# Service Bulletin

Bulletin No.: 03-08-06-001

**Subject:** Bubbles in the Paint Around the Perimeter of the Roof (Replace Roof)

**Models:** 1999-2002 Chevrolet Camaro  
1999-2002 Pontiac Firebird

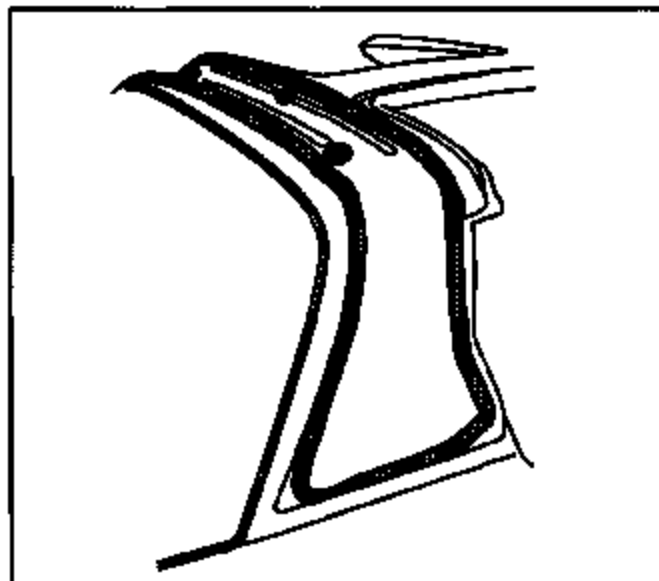
**Condition**

Some customers may comment that there are bubbles in the paint around the perimeter of the roof.

Replace the outer roof panel with a new roof panel following the procedure below:

1. Clean the bottom of the panel with Naptha, then scuff the bottom and clean with Naptha again.
2. Paint and clearcoat the top of the panel. Refer to GM 4901M-2003 Refinish Approved Refinish Booklet, GM 4901 M-D-2003 (English) or 4901 M-D-F2003 (French).

3. Paint the bottom of the roof panel with an epoxy primer. Refer to GM 4901M-2003 Refinish Approved Refinish Booklet, GM 4901 M-D-2003 (English) or 4901 M-D-F2003 (French).

4. Remove the weatherstrip and the run channel retainer on the "B" pillar prior to removing the roof tape off or protect the back light reveal molding.

5. Use the wire method to cut the urethane around the perimeter of the roof. Refer to the above illustration for urethane location.
6. Remove any excess but not all of the urethane from the body.

7. Apply primer 76 mm (3 in) around the perimeter to the roof panel.
8. V cut the urethane tube and apply a 19 mm (3/4 in) high bead around the perimeter of the roof and the three dots across the back.

9. Install new applique to the roof.
10. Install the weatherstrip and the run channel retainer on the "B" pillar.
